Manual Supplement

Manual Title: 752A
Print Date: May 1983
Revision/Date: 1, 4/84

Supplement Issue: **6**
Issue Date: 6/99
Page Count: 8

Figure 1.

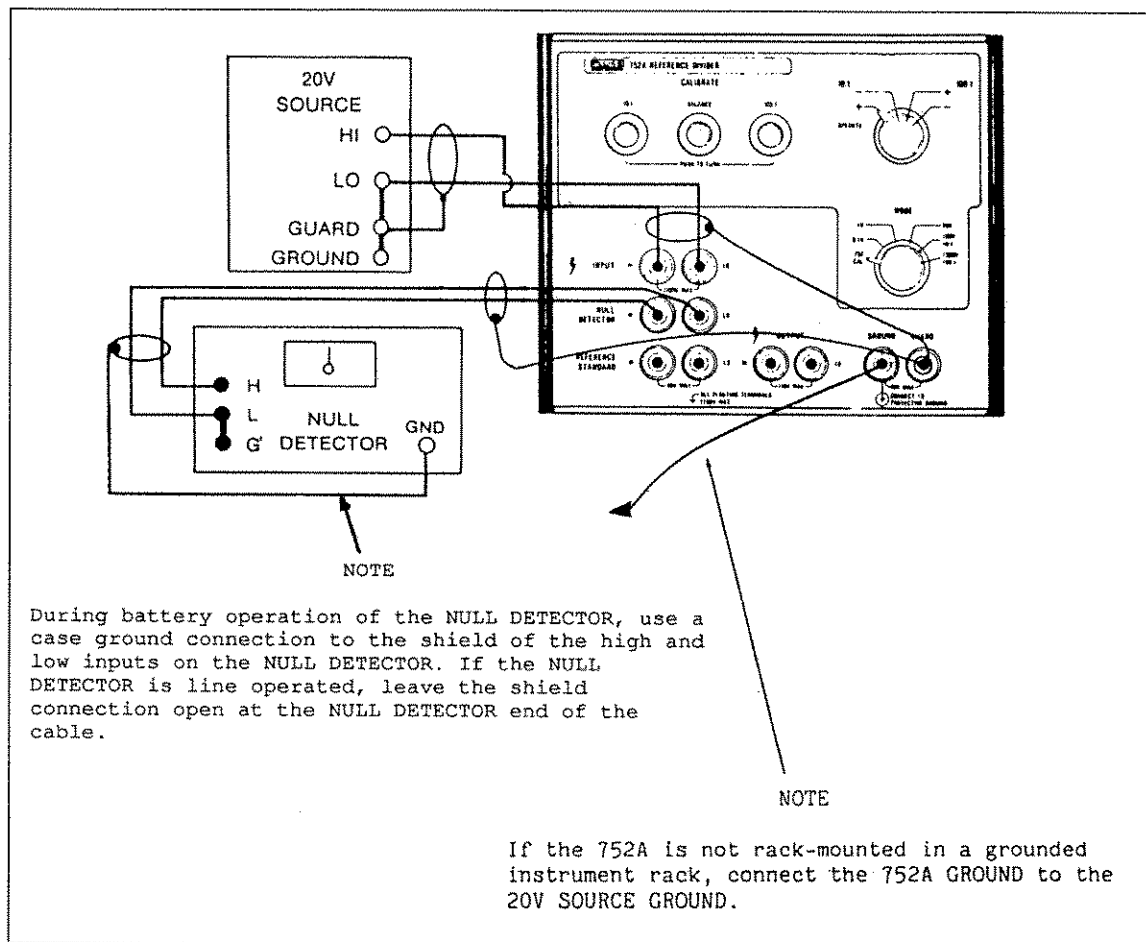
On page 2-4, replace Figure 2-2, with Figure 1.

Figure 2.*Note*

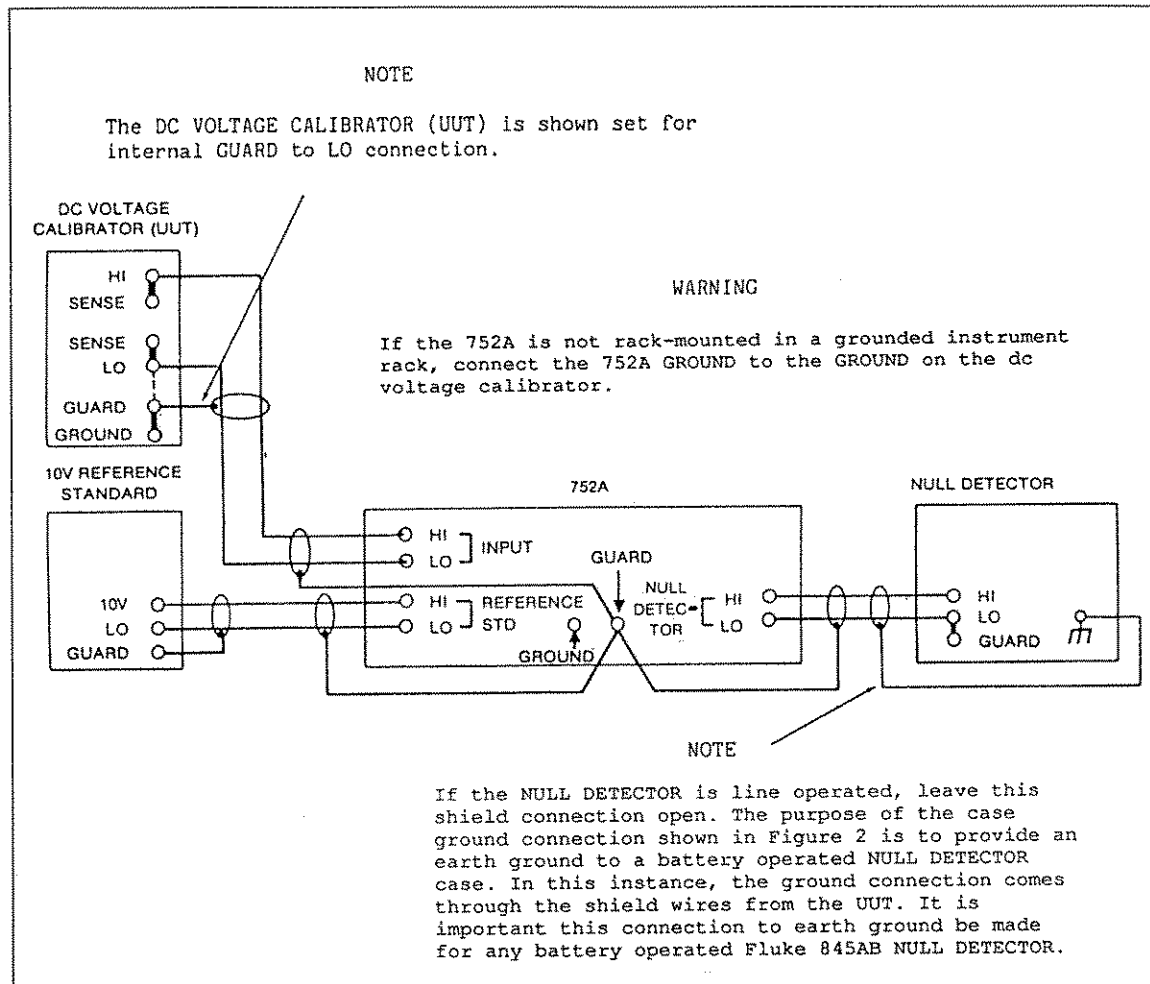
On page 2-6, replace Figures 2-4 and 2-5 with Figures 2 and 3 respectively.

If either the 752A or the KELVIN-VARLEY voltage dividers are not grounded through a rack-mounted case, provide an earth ground for both instruments.

Figure 4. Equipment Connections For Leakage Resistance Test

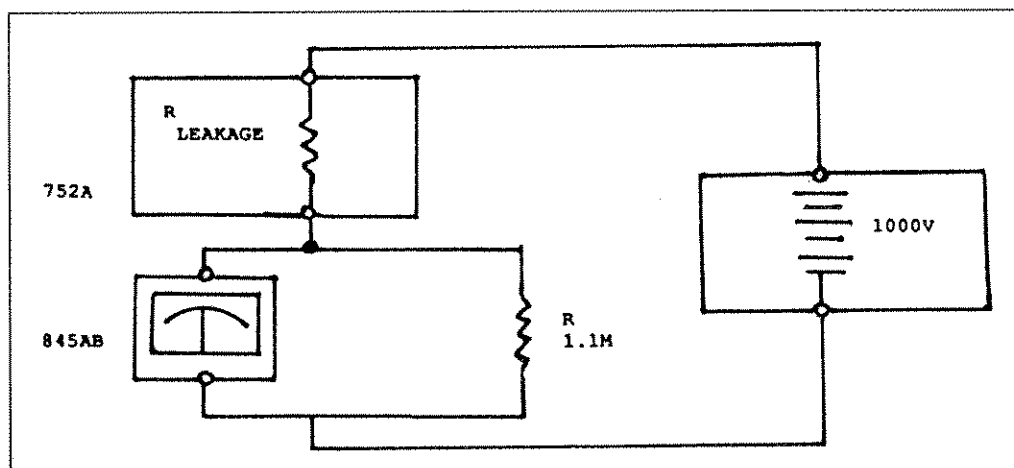
On page 4-7, after paragraph 4-31, add the following procedure:

4-31a. LEAKAGE RESISTANCE TEST PROCEDURE

4-31b. Perform the following procedure to prevent ratio errors caused by leakage. It is recommended that this procedure be done annually. Refer to Figure 4 for equipment connections.

1. Place the 752A on a sheet of dielectric. Use teflon insulated wires to connect the 1000V source to the 752A and 845AB. Connect a 1.1 megohm resistor across the 845AB input terminals to bring the input resistance to 1 megohm.
2. Connect the 1000V source to the 752A Input High binding post.
3. Connect the 845AB positive (+) input to the 752A Guard binding post.
4. Connect the 845AB negative (-) input to the 1000V source negative output binding post.
5. Set the 752A switches as follows:
 Mode switch-----Set to "1000V (100:1)" position.
 Operate switch-----Set to "OPERATE" position.
6. Apply 1000V from the source.
7. The 845AB reading must be 0.5 mV or less to pass.
8. Set the source to standby and change the 845AB positive input lead from the 752A Guard binding post to the 752A Ground binding post.
9. Repeat steps 6 and 7.

Figure 5.

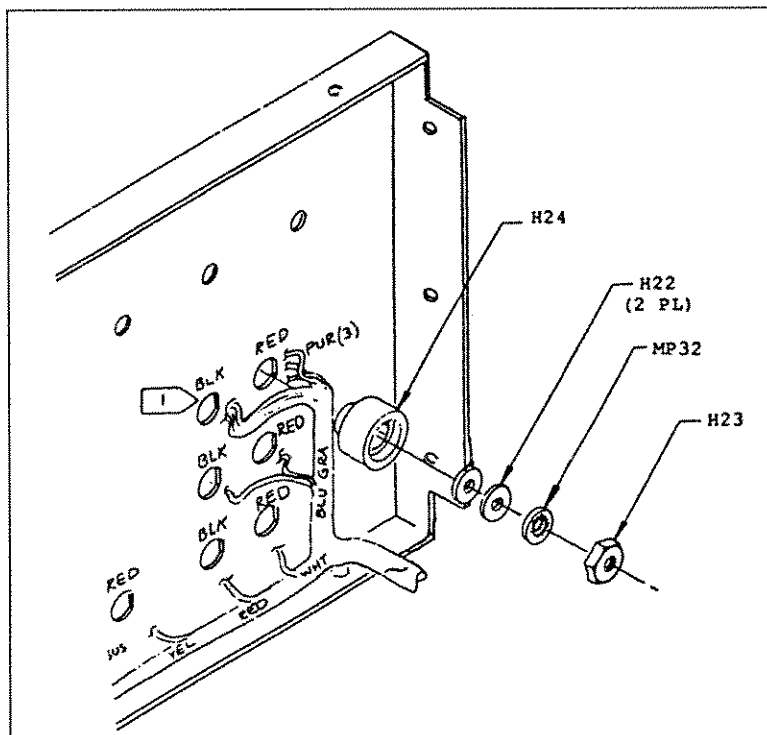
On page 5-5, Figure 5-1, add H22, H23, and H24 as shown in Figure 5.

Add: H22|WASHER,FLAT,BRASS,#8,0.32 THK |631606|86928|5714-162-32|20

H23|NUT,HEX,BR,8-32 |631614|73734|631614 |10

H24|B-P-WASHER |606293|89536|606293 |10

Figure 6.

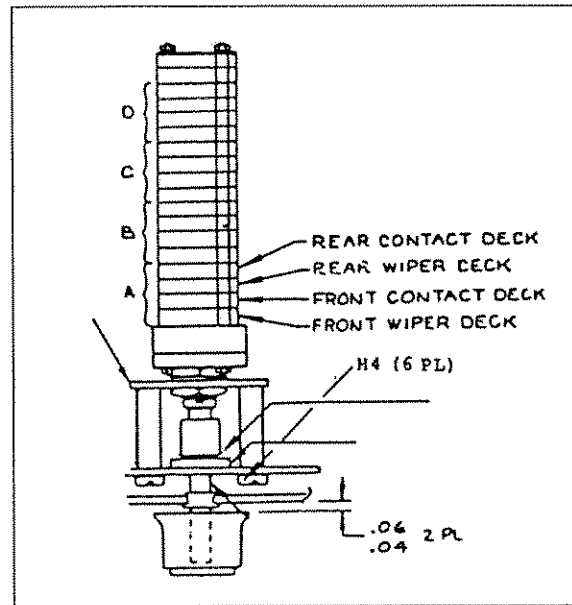
On page 5-5, Figure 5-1, change the view of H4 as shown in Figure 6.

Figure 7.

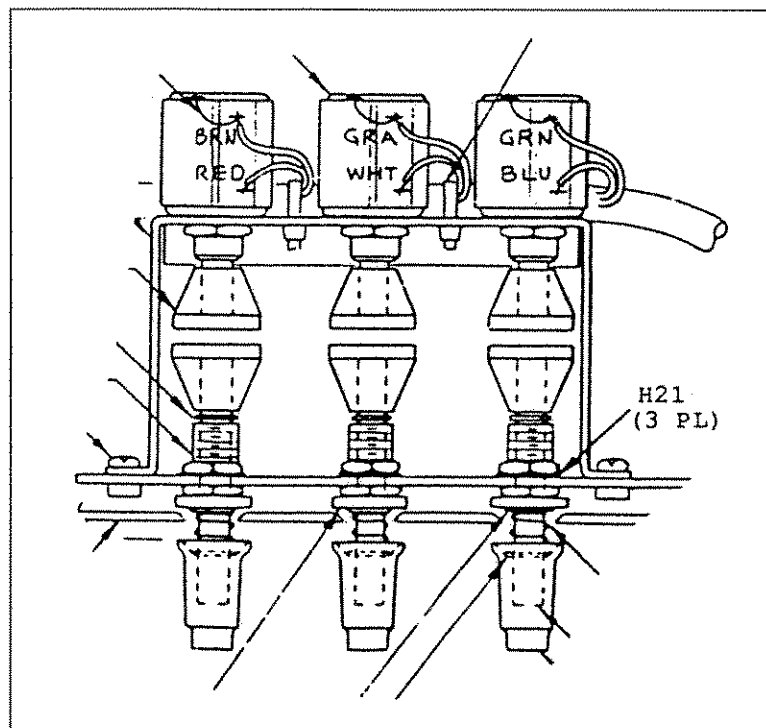
On page 5-5, Figure 5-1, add H21 as shown in Figure 7.

Add: H21|WASHER,LOCK,INTERNAL|129957|78189|1220-05|1
